**SKAGIT RIVER HYDROLOGY  
INDEPENDENT TECHNICAL REVIEW**

**Northwest Hydraulic Consultants**

**March 2007**

## **Consistency of historic data with flooding in Hamilton**

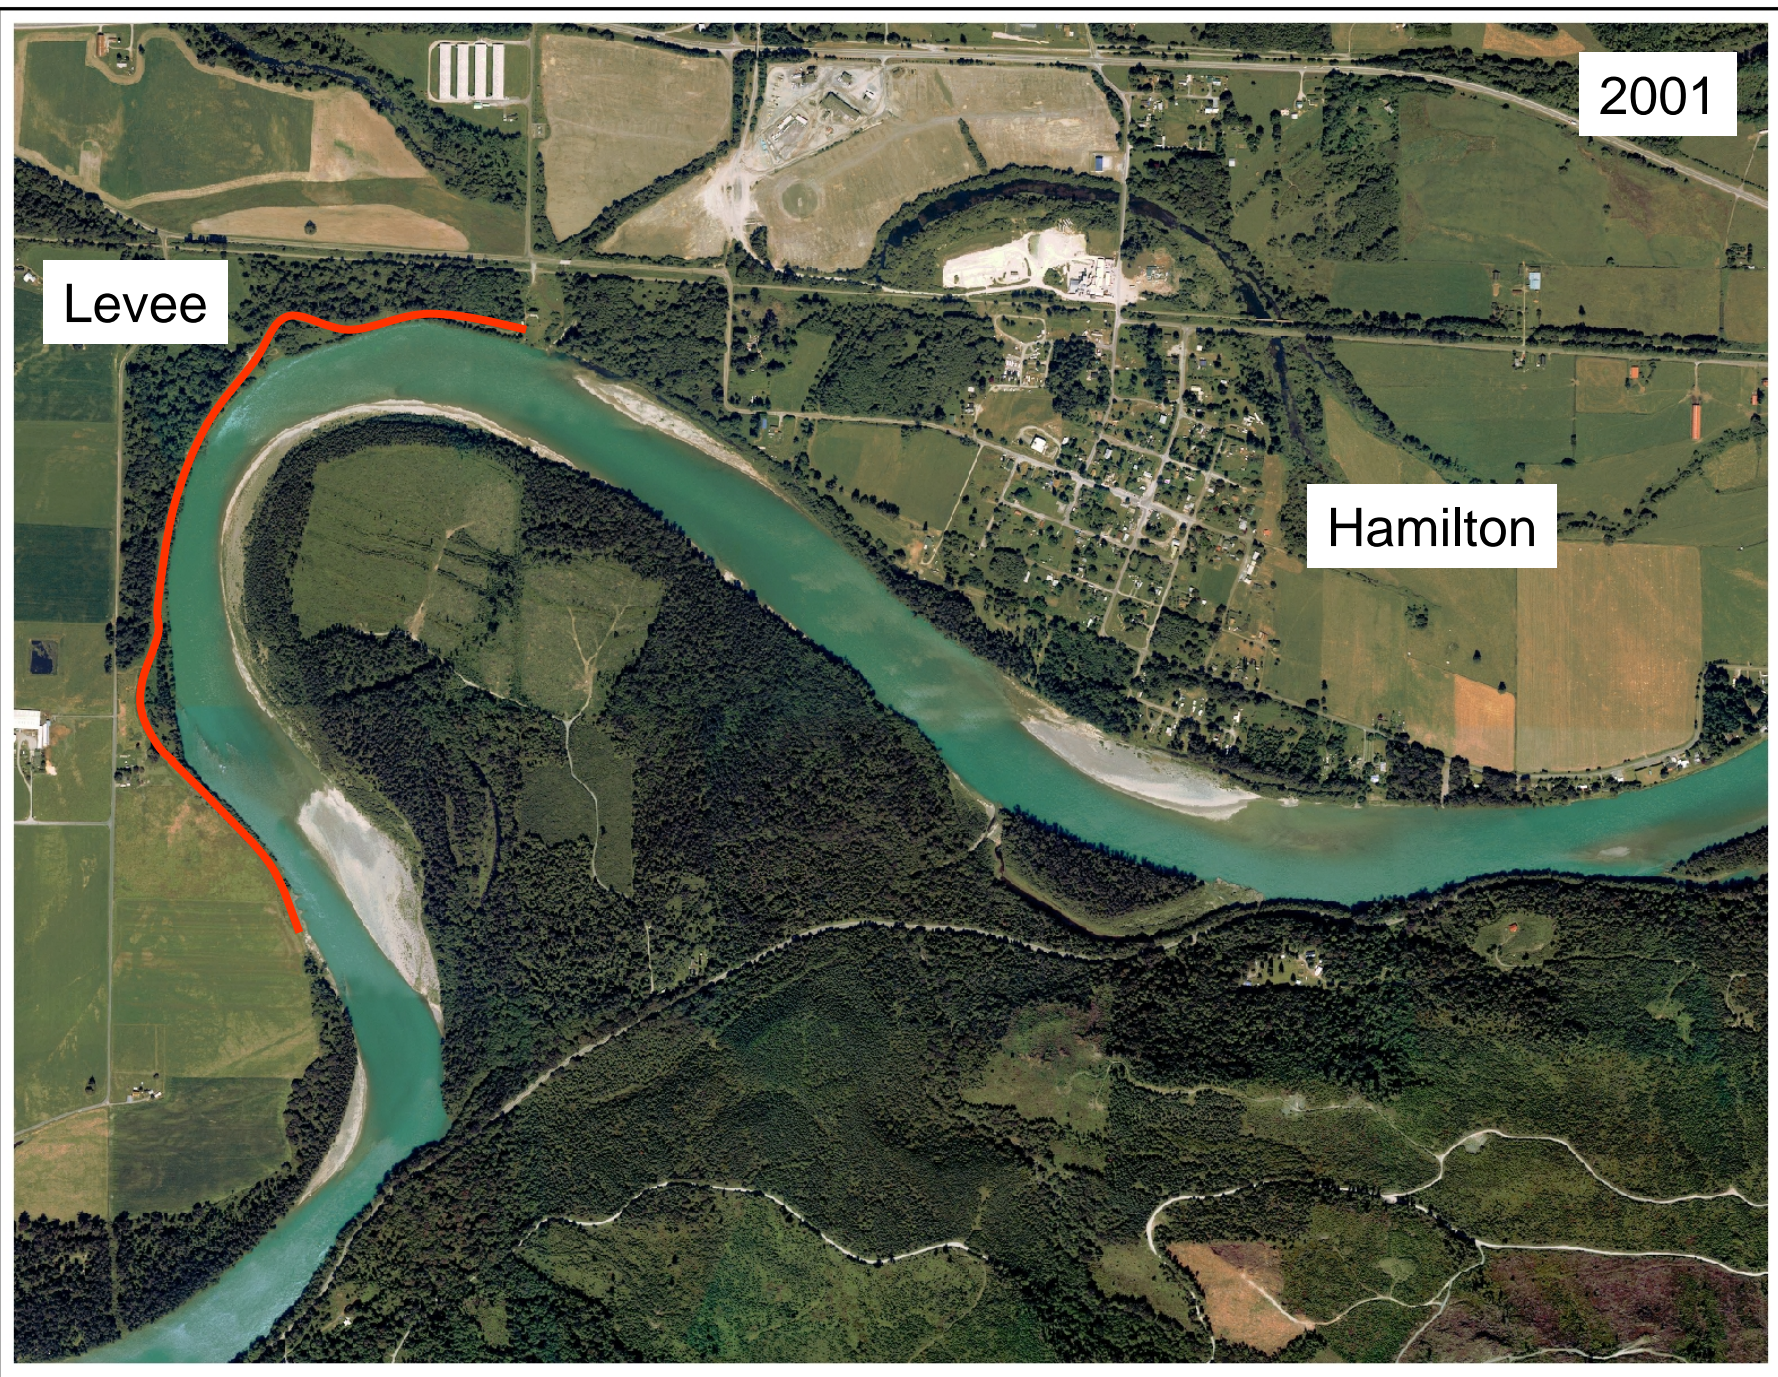
**Issue: Smith House flooded in 1995 (160,000 cfs) but anecdotal reports say it did not flood during historic events - reported peak flows of 260,000 cfs (1910), 220,000 cfs (1918), 240,000 cfs (1922).**

- 1) Anecdotal reports are incorrect and house in fact flooded.**
- 2) Reported historic peak discharges are too large.**
- 3) River has changed since 1922 and historically carried greater flows at lower water levels.**
- 4) Combination of 2) and 3)**

## Effect of Cockreham Levee on Water Levels in Hamilton Assuming 1975 Channel Geometry

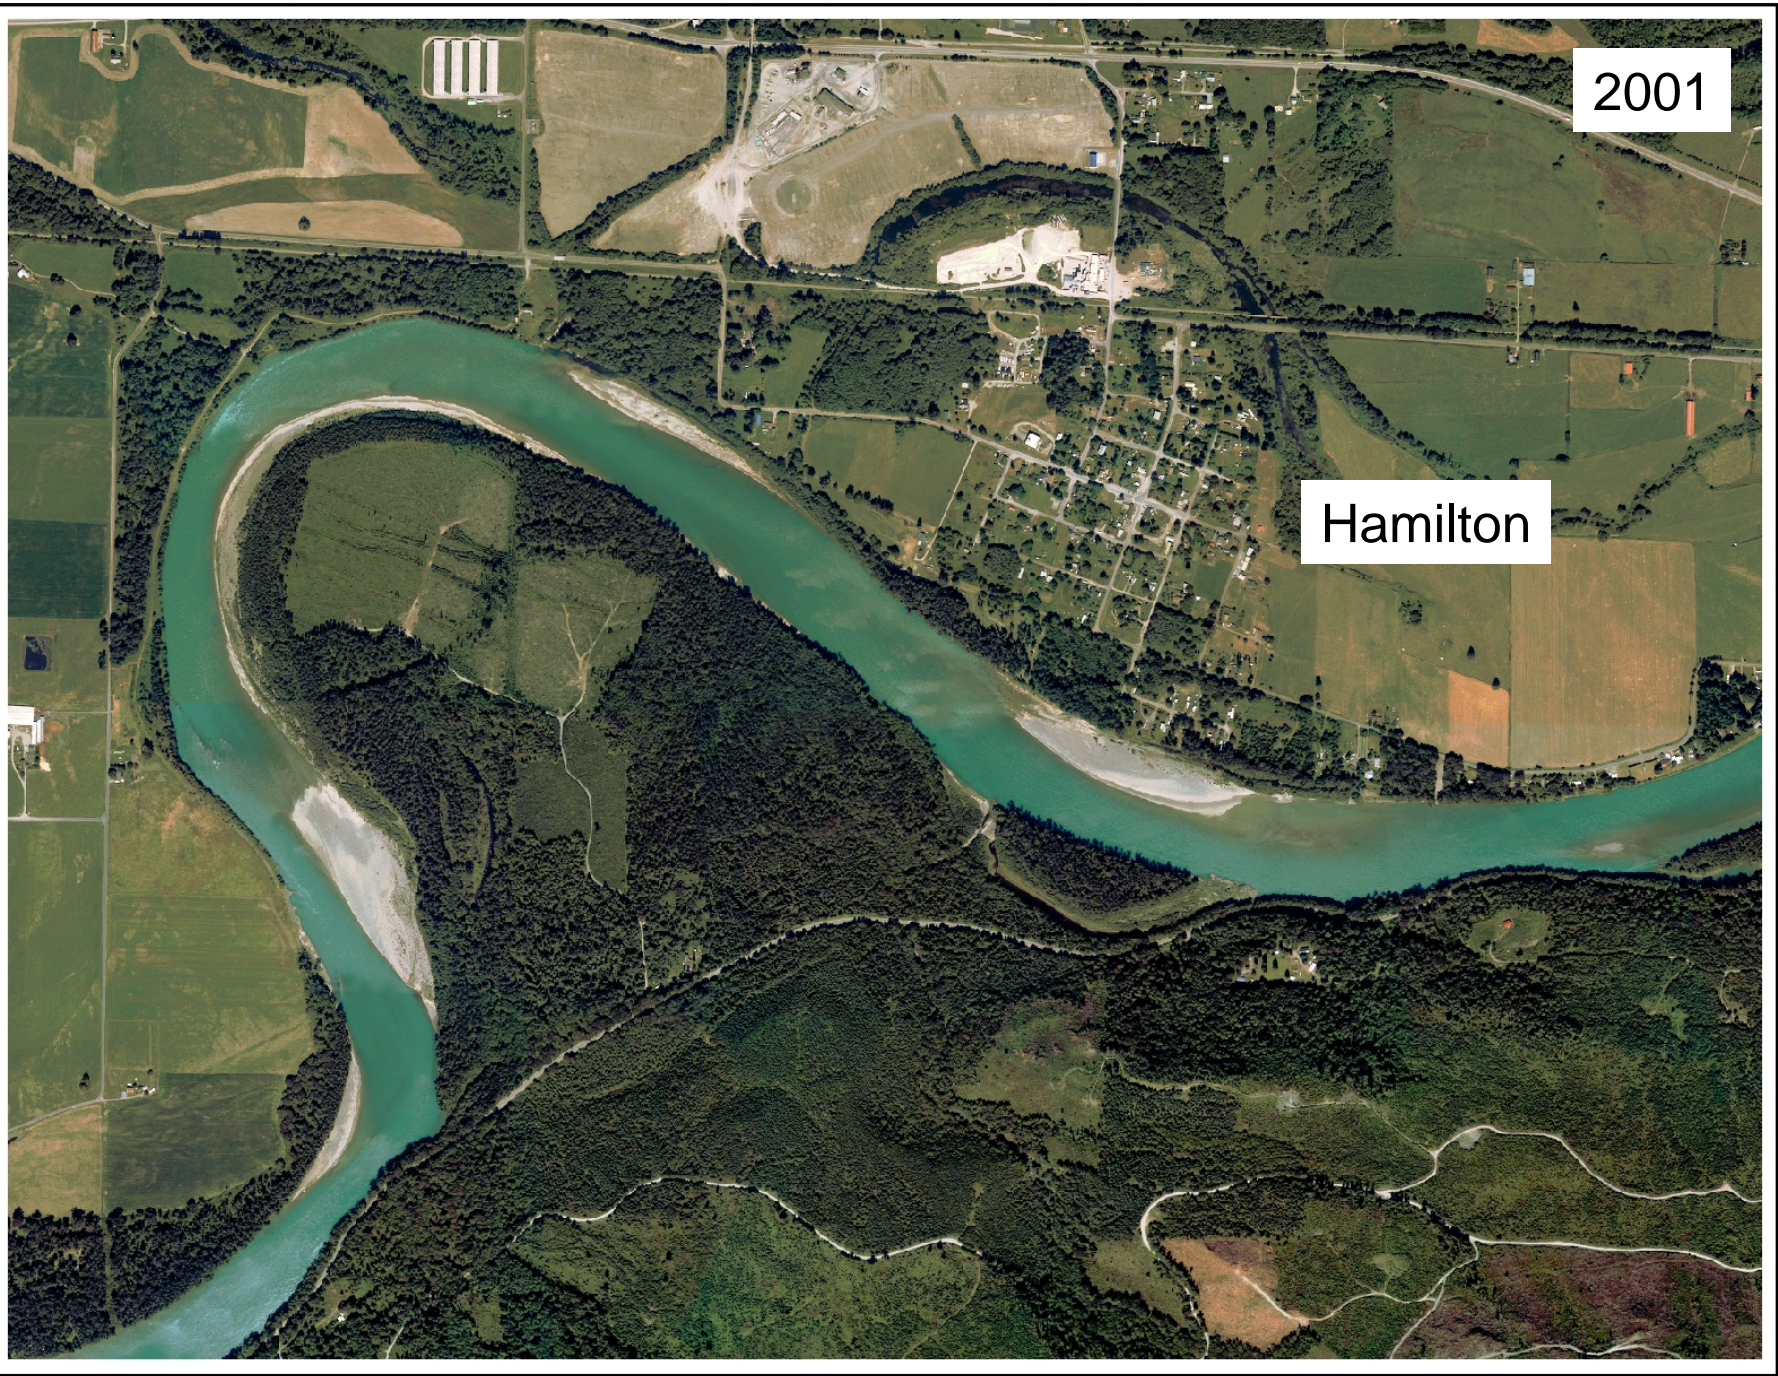
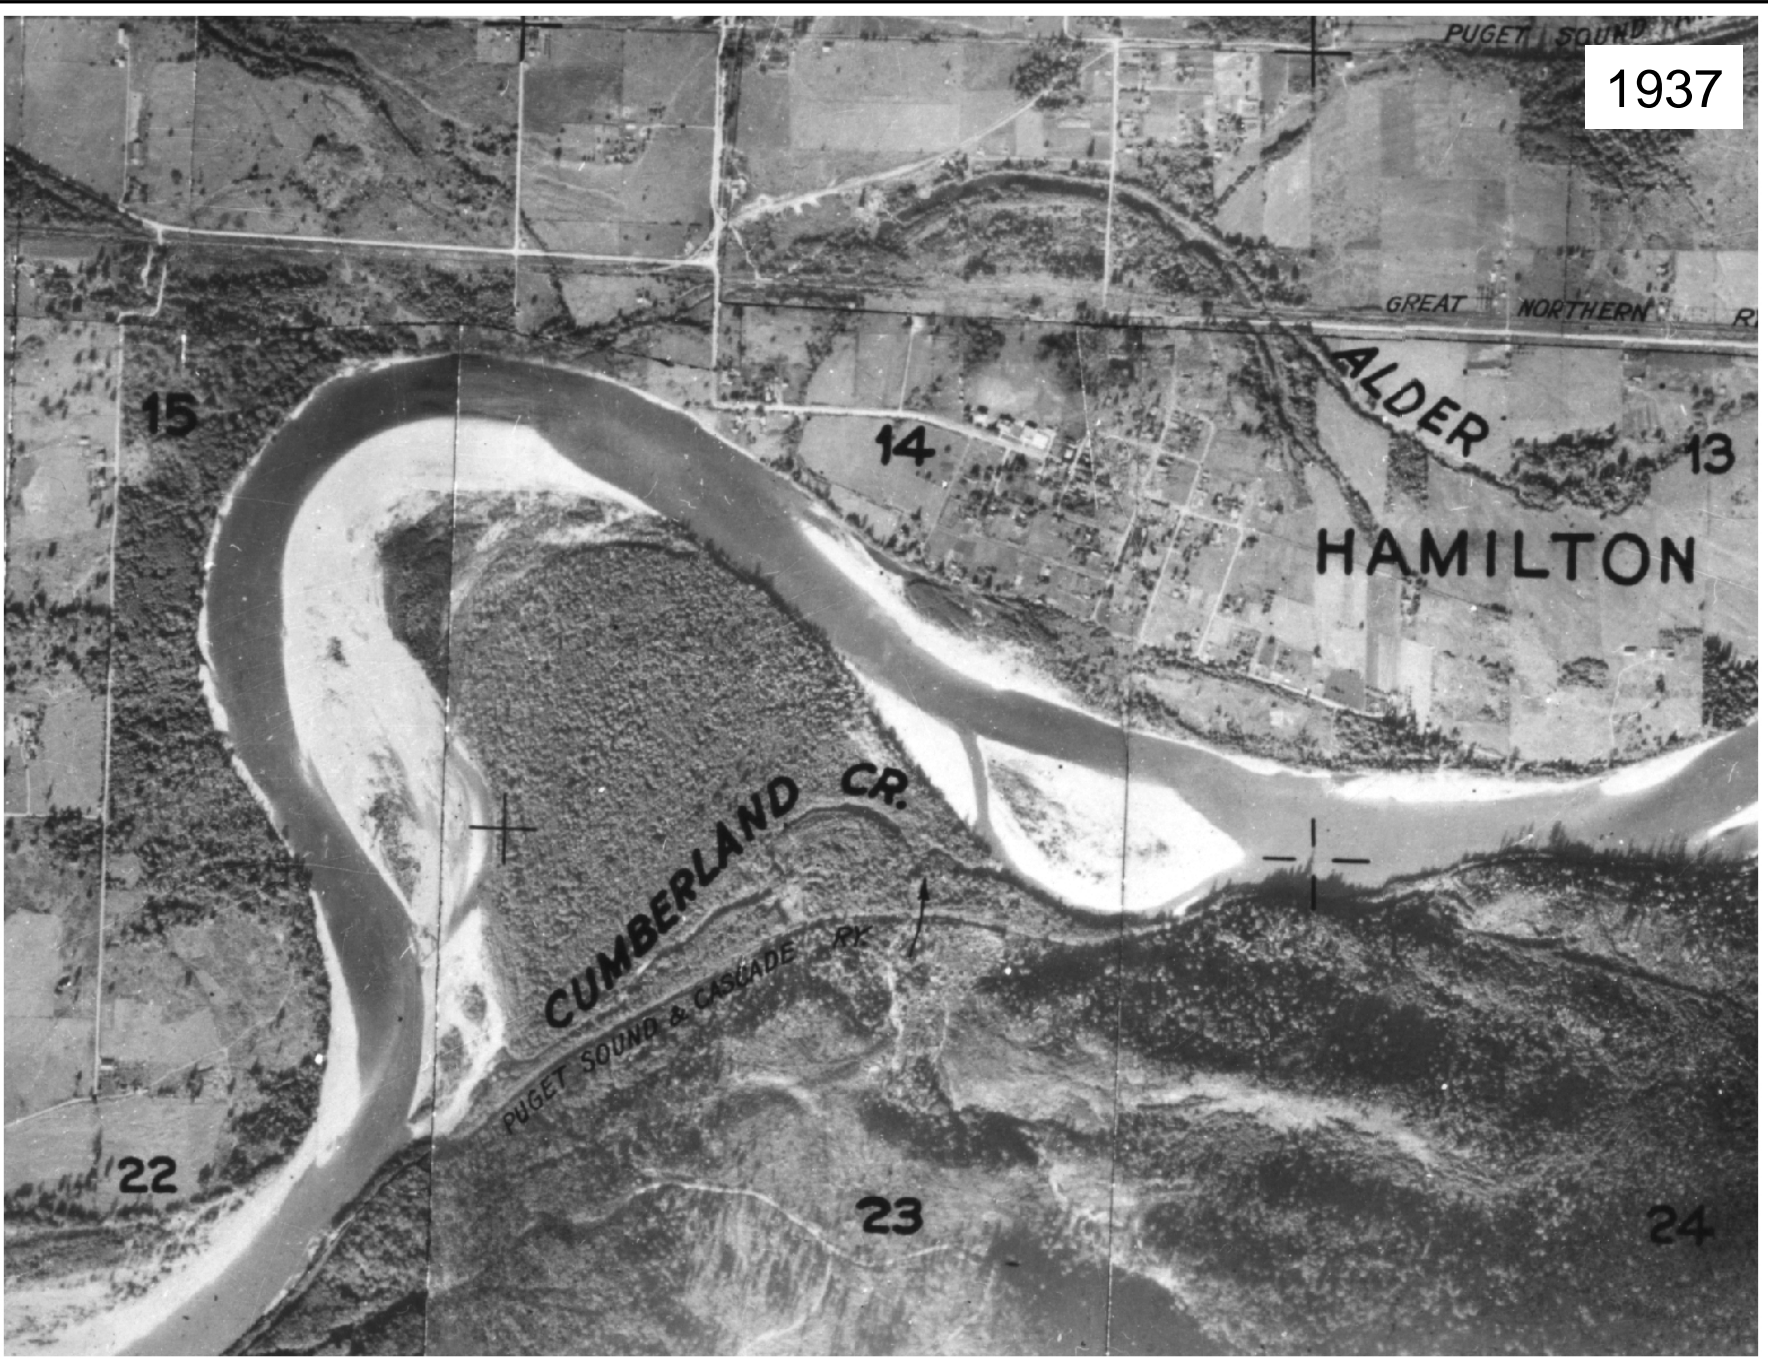
<b>Flood</b>	<b>Discharge (cfs)</b>	<b>Water Surface Elevation in Hamilton (ft)</b>	
		<b>Without Levee</b>	<b>With Levee</b>
December 1921	240,000	102.7	103.9
November 1995	160,000	99.1	99.7
